UNITED STATES PATENT AND TRADEMARK OFFICE

Office Action Summary

10/674,198

DETAILED ACTION

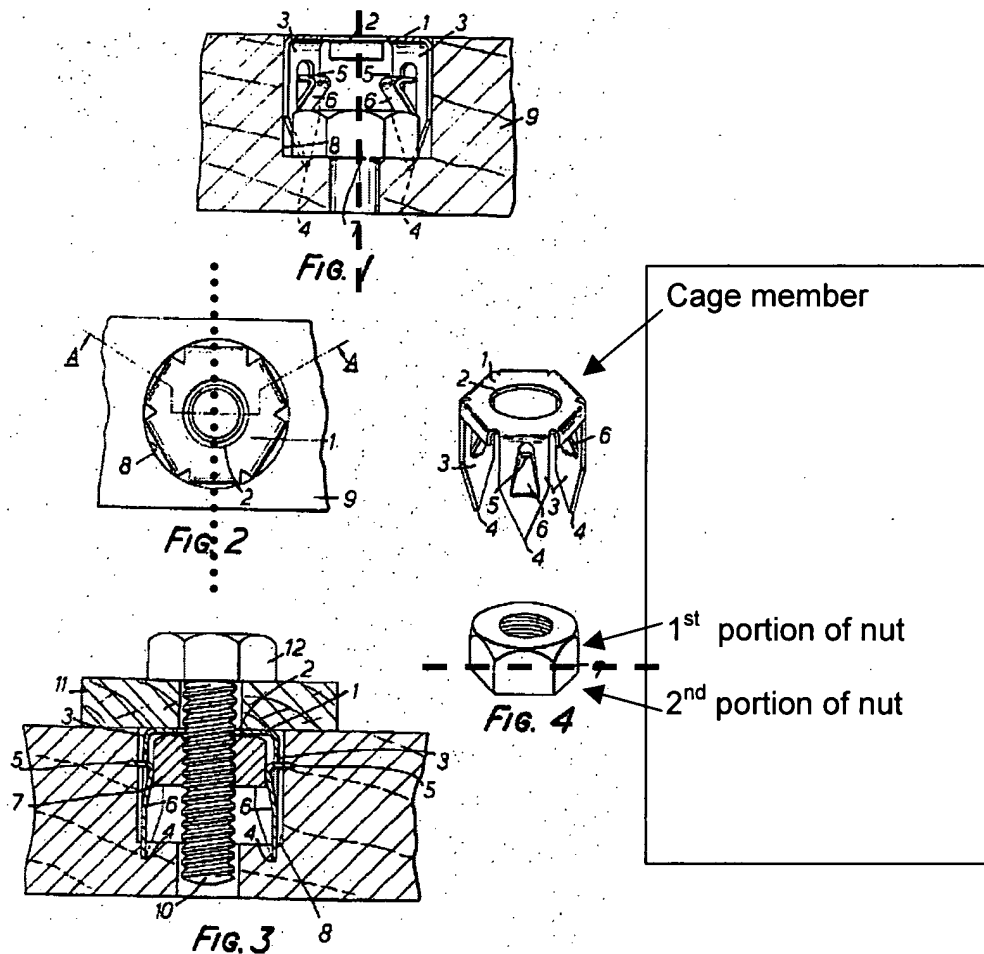
Re claims 1 and 10: Parkin teaches a cage member (upper item in Fig 4) engageable with nut 7 having first and second portions and an aperture extending at least partially therethrough, (note that applicant is not claiming the nut, and a nut is capable of having distinct first and second portions. **However, further regarding claim 10**, the nut of Parkin can be considered to have a 1st portion [upper section in the figures, having the tapered sides] and a 2nd portion [lower section without taper]) thereby providing a cage nut assembly, said cage member comprising:

Said body defining a base portion (1) and at least one wall portion (3) and configured to engage the nut first portion such that the nut second portion does not come into contact with either the base or said at least one wall (Fig 1- notice that neither portion of the nut contacts the base or at least one wall, and in Fig 3, the 2nd portion does not contact the base or a wall 3), said body provides a limited range of nut movement in at least one dimension (axially along what could be called the bolt axis - see dashed line by examiner in Fig 1 above, although there is slight radial movement

Re claims 2-3, 5, 11-12,14: Said upper portion comprises at least one arm (6). Looking at Fig 2, note that there are at least two arm portions (6) which are positioned on opposite sides of a plane that bisects the base (see Fig 2 and examiner-drawn dotted line for plane), thus they are positioned opposite one another. The arms define an opening sized to receive the nut member therethrough when the nut 1st portion is engaged by said 2 arm portions (See Fig 3). Examiner notes that applicant did not require the arm to extend **directly** from said base.

Re claims 6,15: Fig 1 shows each arm 6 with a generally "C" shaped portion, and forming an opening between opposite arms.

Re claims 7,19: Looking at the difference in arm 6 between Fig 1 and Fig 3, it is clear that it is inherently flexible.

Re claims 8,20: As best understood, at least one arm portion can be moved (see Fig 1 and 3 comparison of arm for movement) to allow the 2nd portion of the nut member to be positioned above said base (entire nut is always above said base). Nut is between at least one wall portion of said body and something - an opposite wall.

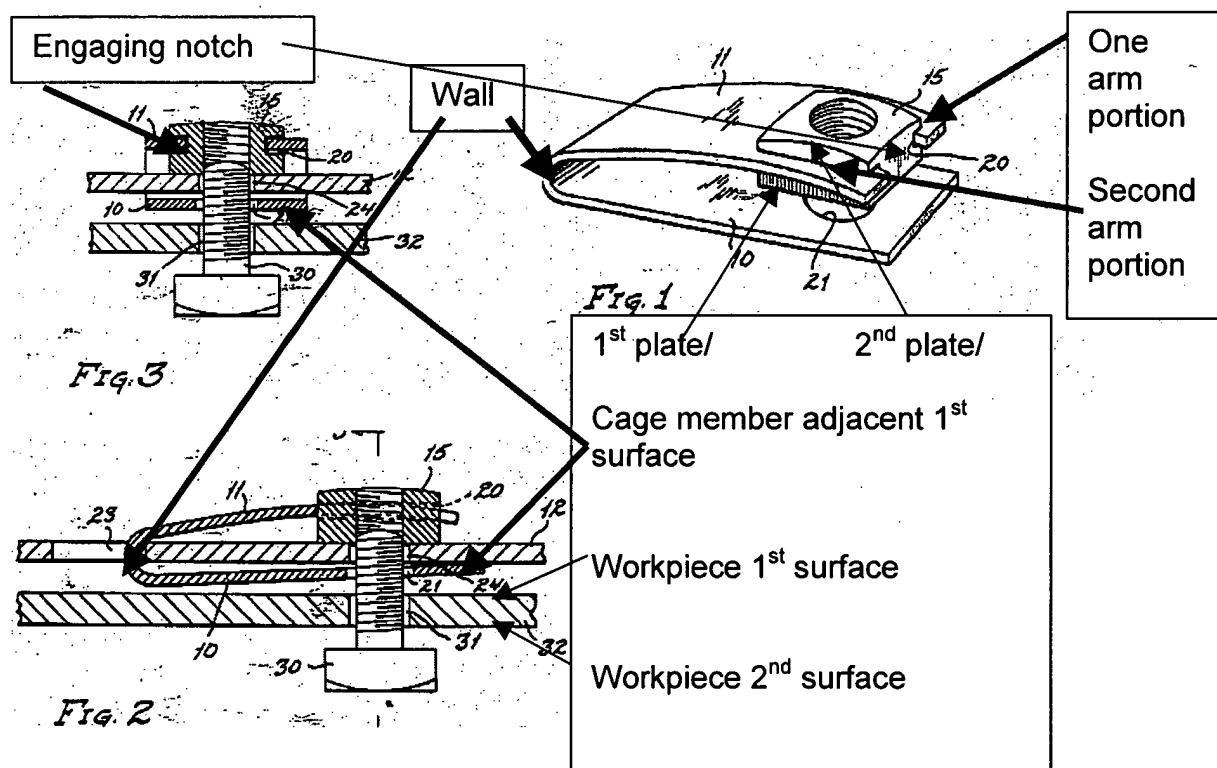
Re claims 1,2,3, 7,8,10,11,12,19,20: Tinnerman 342 in Figs 1-3 teaches a cage member and nut assembly, said nut (15) having a 1st and 2nd portion (see marked up

drawings below) enclosed by a cage member (10/11) which has a body configured to engage the nut member such that the nut member is encaged. The cage further comprises a body (11/10), and "11" is considered the upper cage/arm portion, and "10" is the base. The wall is labeled by examiner in drawings below. The nut engagement is such that the 2nd portion (same as the portion labeled "1st plate" below - looking at the drawings as oriented, it is the "lower" part of nut below "11") of the nut does not come into contact with either the base or the wall. Figs 1 and 3 shows a limited range of motion in at least one dimension. The body provides a limited range of nut movement in at least one dimension (axially along what could be called the bolt axis - although there is slight radial movement also).

Further Re claims 3 and 12: As shown in Fig 1, arm portion 11 forms two arm portions at the end as labeled by examiner in drawings below. These two arms are opposite each other.

Further Re claims 8 and 20: As best understood by examiner, the at least one arm 11 can be moved to allow nut 2nd portion to be positioned over base and between the wall and something - in this case the very end extension of the arm 11 past the notch.

Re claim 32,37: The body further comprises at least one wall (see label by examiner above), and Figs 1- 3 show the nut engaged such that the nut does not contact at least one wall.
